January 3, 2025

Project No. 10853-270

Subject: Response to Comments – Administrative NOD  
Asphalt Inc.  
WPAP – Ronald Reagan Quarry  
Georgetown, Williamson County, Texas

### WATER POLLUTION ABATEMENT PLAN BOUNDARY EXHIBIT

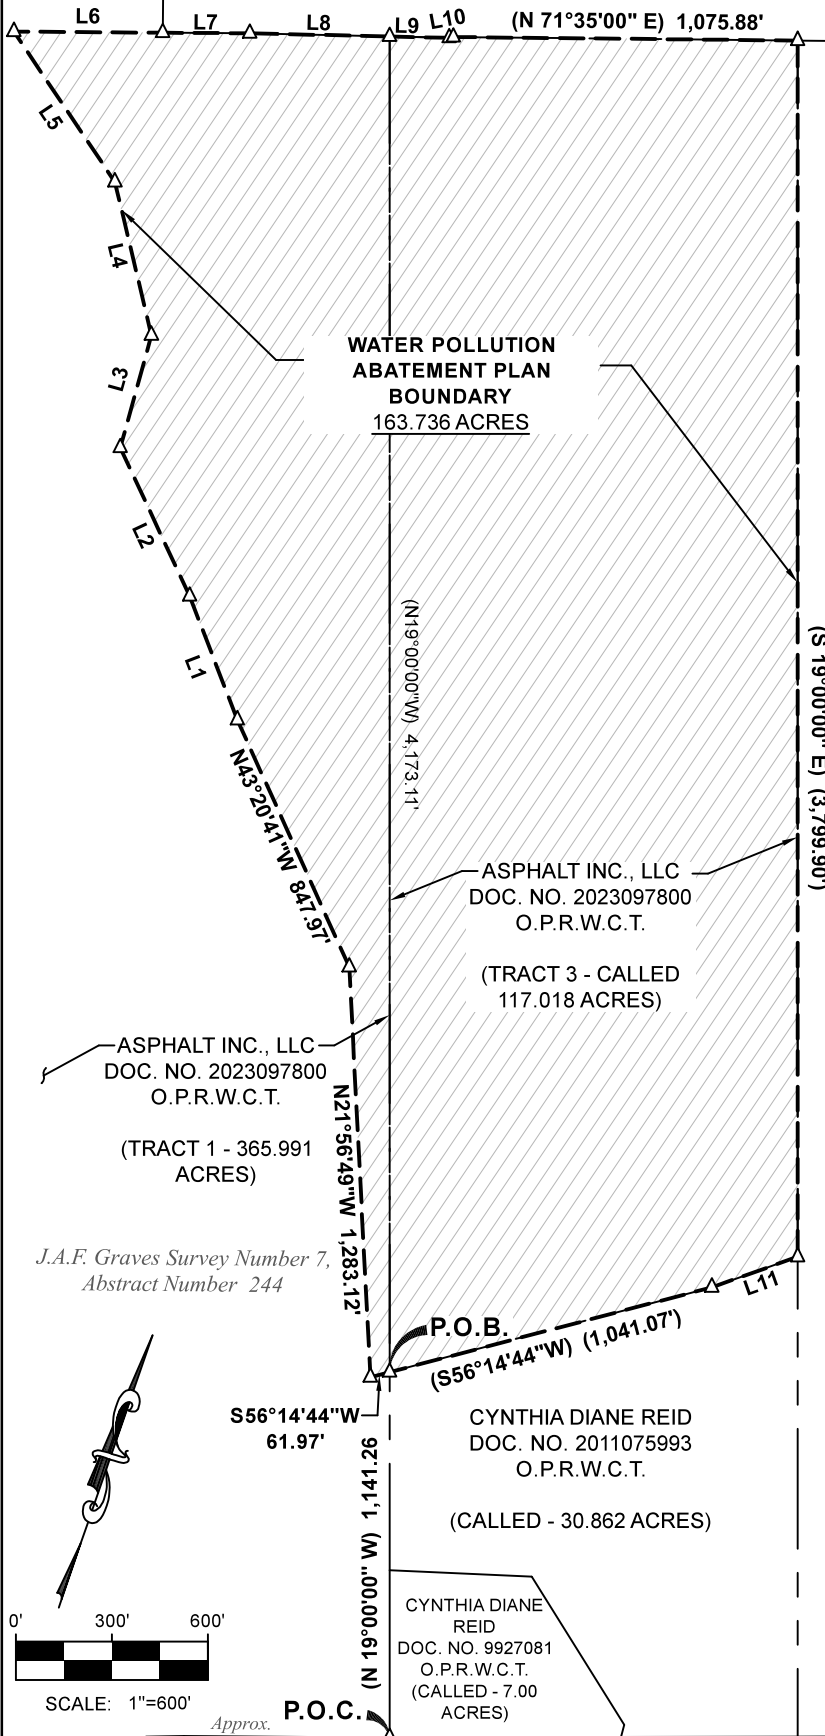
*Comment 1: Site is defined as the entire area included within the legal boundaries of the property as described on the Williamson CAD Map. If legal boundaries have changed, please include documentation from the county within the revised application. If proposing Metes and Bounds, include a RPLS sealed and signed survey within the revised application. If not, please update information throughout the application to reflect the acreage as described on Williamson CAD Map.*

**Response 1: Please see attached Boundary Exhibit including a metes and bounds, RPLS sealed and signed survey.**
